AMENDMENT OF SOLICITATION/CONTRACT (AGREEMENT)

BUMP OUT 2

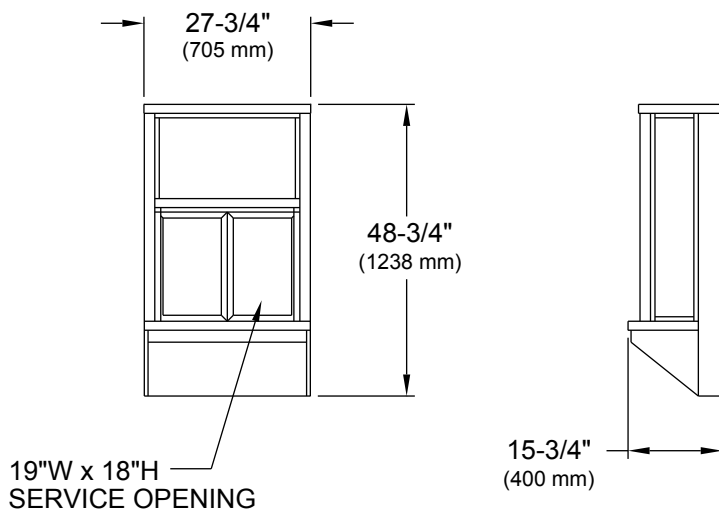
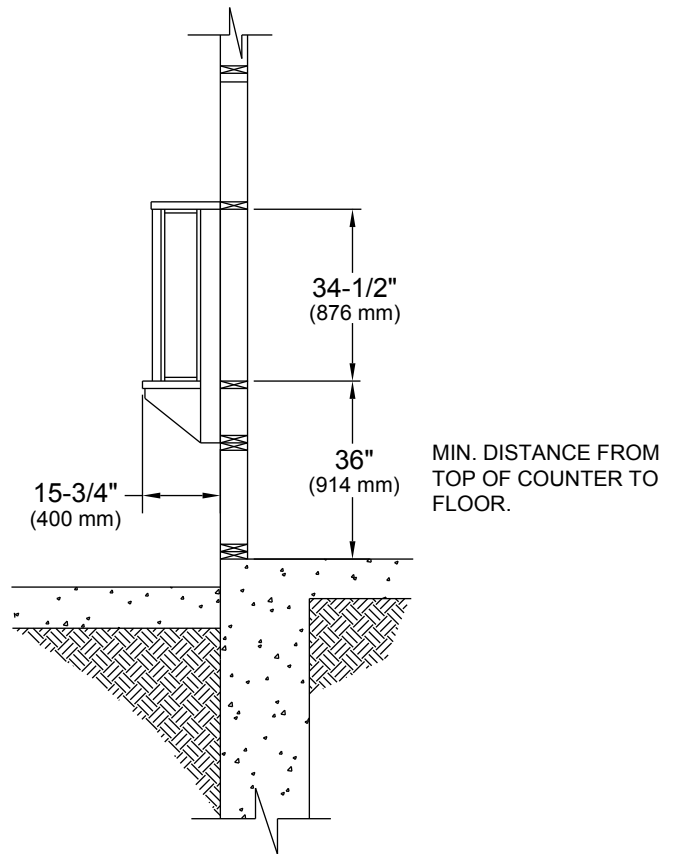
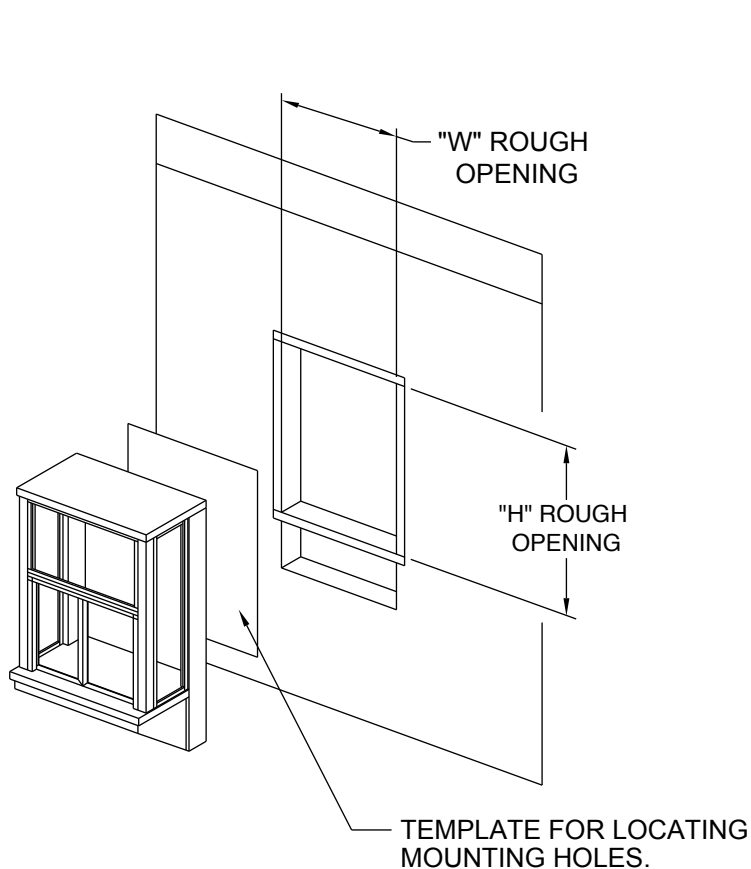
6. QUESTION: Are the drive through windows shown on sheet A1.2 to be furnished and installed by the contractor, please advise. If so can you please send specifications and add to the door and window schedule.

ANSWER: Drive-Thru Windows; all items shall be furnished and Installed by the Contractor unless otherwise noted; therefore, yes the Contractor Furnishes and Installs. The Contractor shall furnish the "Ready Access Bump Out 2" Drive-Thru Window as specified which only comes in one dimension. The Window size is on the attached Cut Sheet (Inclosure #1 consisting of 2 pages).
